Public Meeting
 ALTERNATIVE SOURCE TERM REGULATORY GUIDANCE (DG-1081; SRP15.0.1)
 February 15, 2000

Comments on DG-1081 Gap Fission Product Content

Specific DG-1081 "Gap Fraction" Revisions
DRAFT – 2/15/2000

Fission Product Content in the Fuel Rod Gap

Composite Data From Both Reports With Bounding Envelope

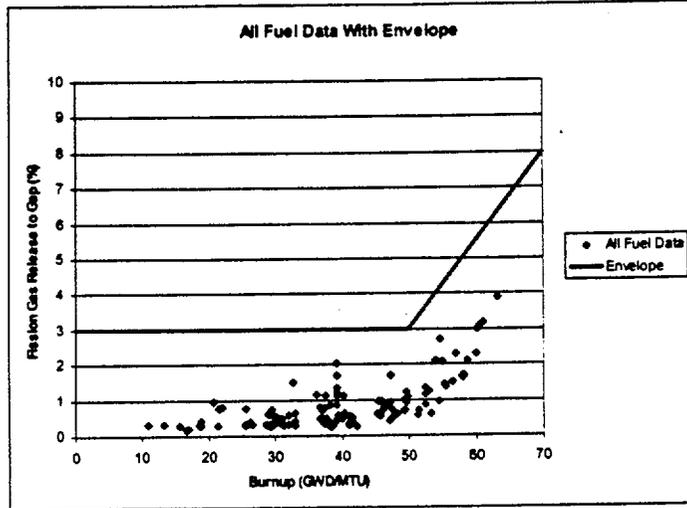
- The ANS 5.4 model, used traditionally, is overly conservative due to its exponential burnup-dependent multiplier, based on:
 - few data points
 - plutonium/uranium mixed oxide fuel
- The NRC FRAPCON-3 model and analysis have not provided to industry
- High-burnup gap content measurements from actual fuel rods are available
- Fuel rod behavior for the control rod ejection event is being addressed in NRC's high-burnup fuel research and evaluation program

Rod Average Burnup (MWD/MTU)	Industry Proposed Gap Fraction for Use in Design Basis Analysis - No Heatup (%)
0	3
20,000	3
30,000	3
40,000	3
50,000	3
60,000	5.5
62,000	6.0
70,000	8.0
75,000	9.25

Example of Bounding Envelope of Fuel Rod Power Vs. Burnup

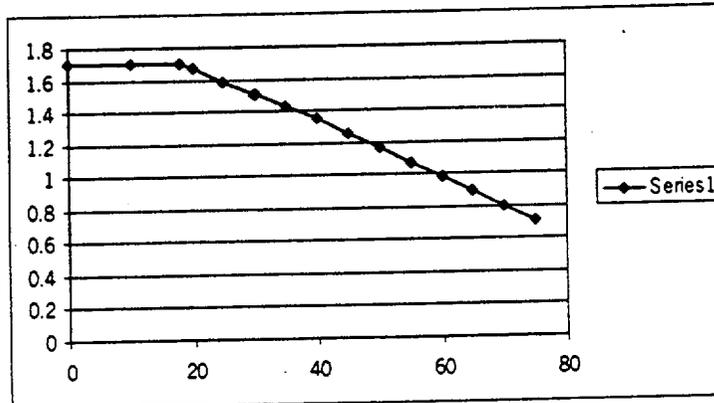
- Fission product content in fuel-cladding gap =
(total fuel rod content) x (percent released from pellet)
- Total fuel rod content = (core average fuel rod content) x (radial power peaking factor)
- NRC proposes using the maximum power peaking factor for all burnup levels
 - industry believes this is excessively conservative
- Industry proposes using a power peaking factor that bounds actual analytical results

- For low-burnup fuel (<30,000 MWD/MTU), use the radial power peaking factor from the Core Operating Limits Report (COLR) Power Peaking Factor for Core Inventory Calculations
- For fuel with higher burnups, use a radial power peaking factor based on the bounding power history envelope associated with the fuel cycle design being used
- if a radial power peaking factor from a power history envelope is not available, use the low-burnup value from the COLR
